28 Kylemore Road
NW6 2PT

Basement Impact Assessment
Audit

London Borough of Camden

Project Number: 12466-93
Revision: F1

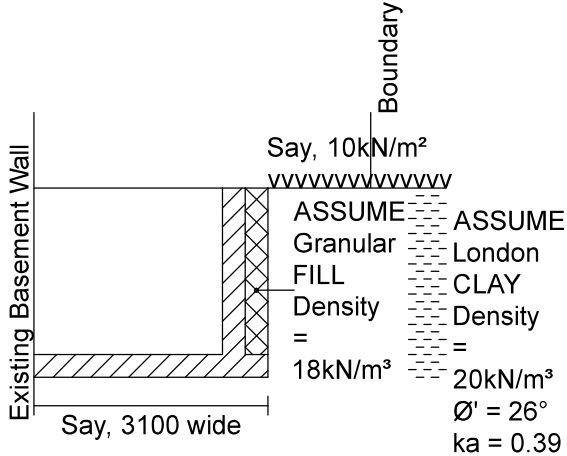
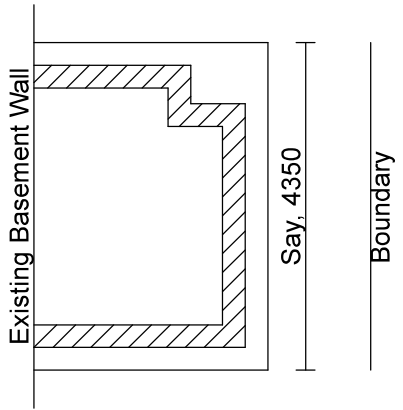
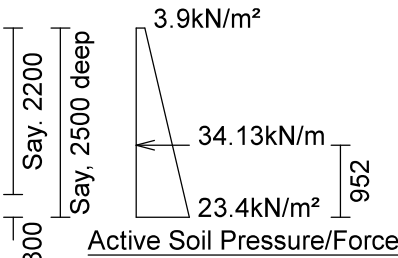
- 4.10. Outline structural design calculations is being provided. At this stage, the ground water is not being considered but an adequate groundwater level must be account for on the final design of the retaining wall. It is suggested that the retaining wall could be reinforced concrete or reinforced brickwork but, although we accept that brickwork could be an acceptable construction material for the retaining wall, the methodology presented would not allow for the waterproofing the back of the wall, potentially reducing the durability of the retaining structure. For this reason, it is recommended the use of reinforced concrete.

- 5.10. The outline of the retaining wall structural design calculations is provided. Groundwater pressure, not included at this stage, must be considered in the final design. The construction material of the retaining wall should be reinforced concrete and not brickwork.

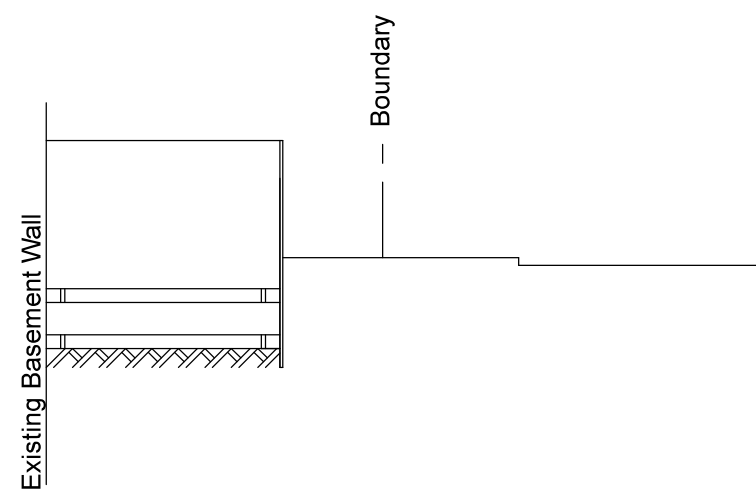
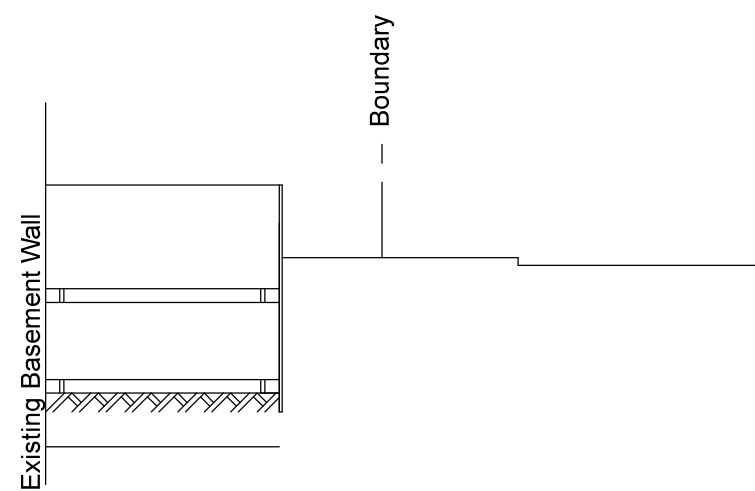
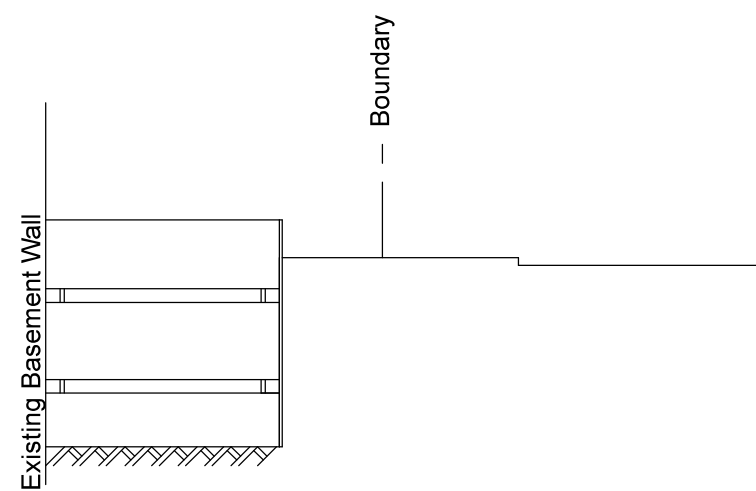
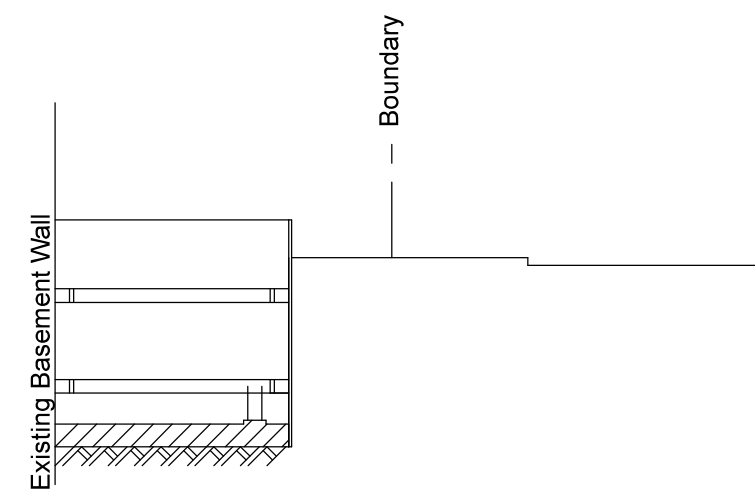
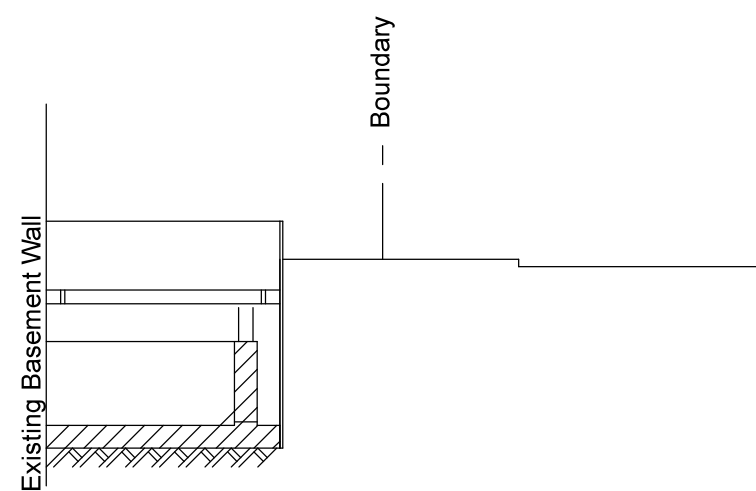
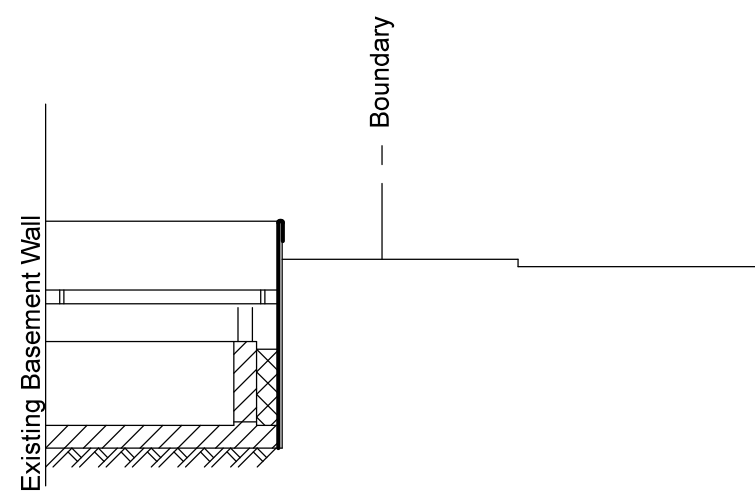
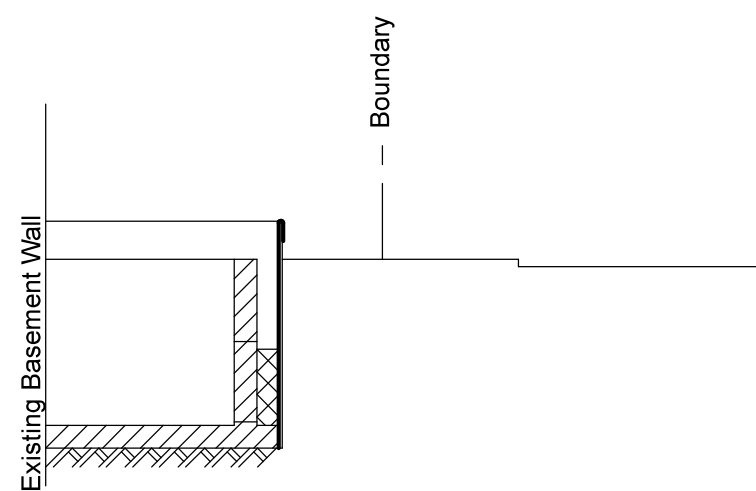
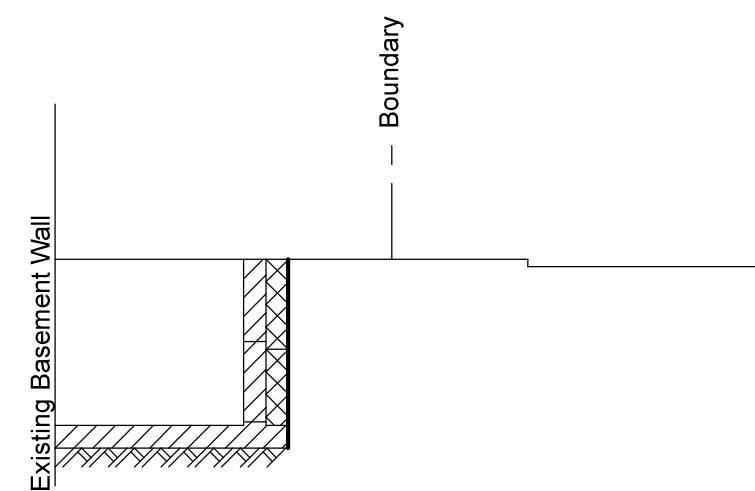
- 4.9. A construction methodology is presented for the lightwell construction which indicates the use of propped trench sheeting progressively lowered into the ground as the excavation proceeds, with the reinforced concrete retaining wall constructed inside of the trench sheeting. The void between the trench sheeting and the concrete wall is to be progressively filled as the wall is constructed, with the trench sheeting removed once completed. With reference to KEY GS drawing number 17-135-D-003, the Trench sheets should be moved up to mid height between stages 5 and 6 and then completely removed between stages 7 and 8, to avoid soil relaxation after backfill is completed. It is accepted that the method of construction has been thought out to ensure support to the retained ground at all times which is accepted, however good workmanship and an experienced contractor is should be ensured to ensure that ground movements are minimised.

- 5.9. A construction methodology is presented for the lightwell construction which indicates the use of propped trench sheeting, with the reinforced concrete retaining wall constructed inside of the trench sheeting. Subject to the comments pointed on section 4, the construction methodology is found to be acceptable given good workmanship.
